Subject: RE: 22 Beach Road, Littlehampton.

I write further to the client providing me with your feedback on the AASL acoustic report dated 6th June 2019 for the above site.

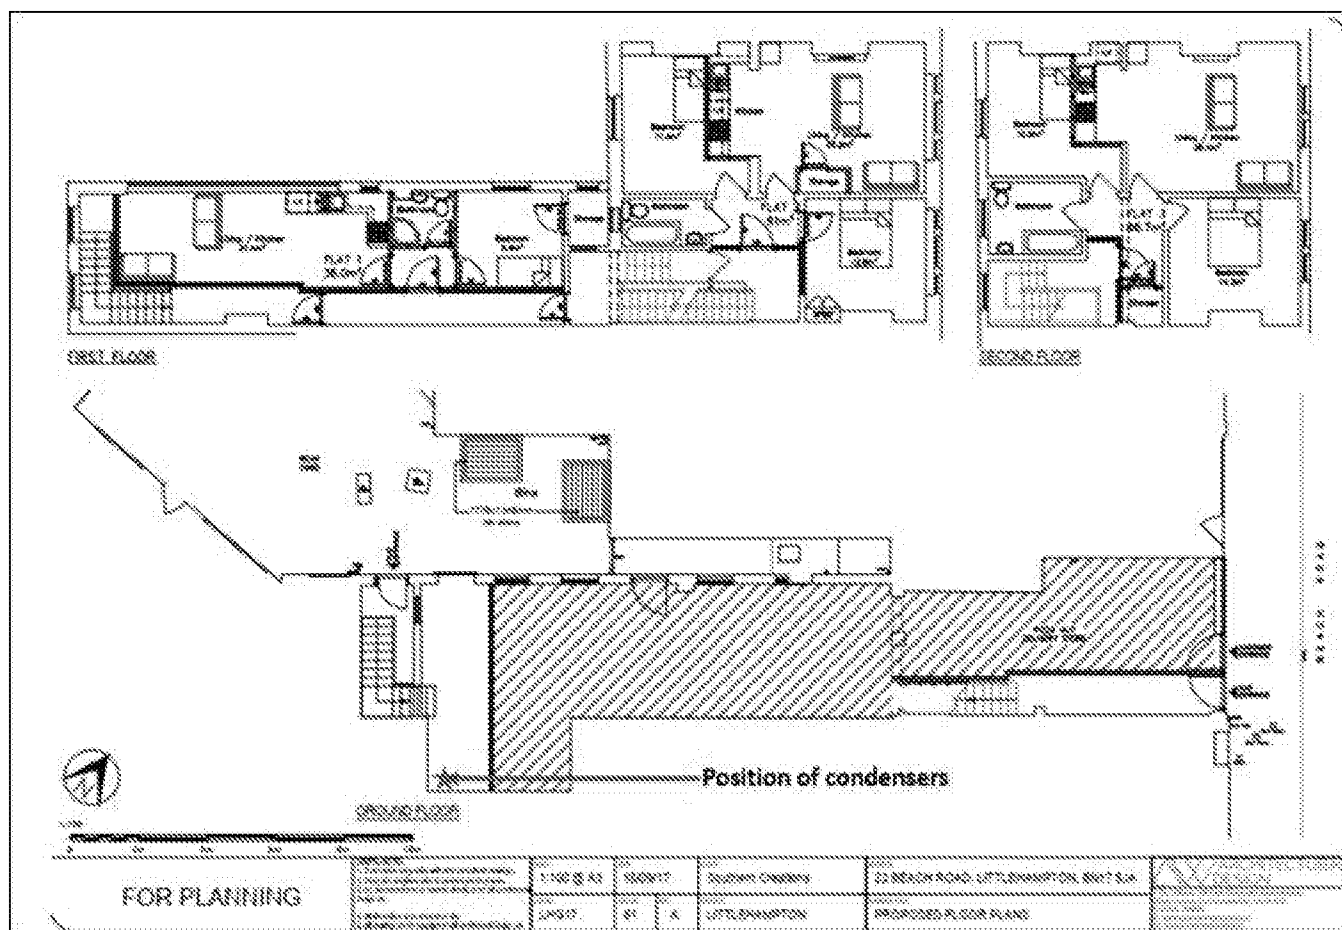
1. The condenser unit for the Walk in chiller.

The condensers were previously located below the bedroom window but have since been relocated to inside the rear garage unit at the very rear of Flat 1, outside the demise of the flat.

The condensers are mounted on anti-vibration mounts on the ground floor. Both the garage and the pizza hut ceiling were soundproofed at the same time. The condenser positions inside the garage void are shown below.

The condensers would have run as part of the survey and are contained with the survey data.
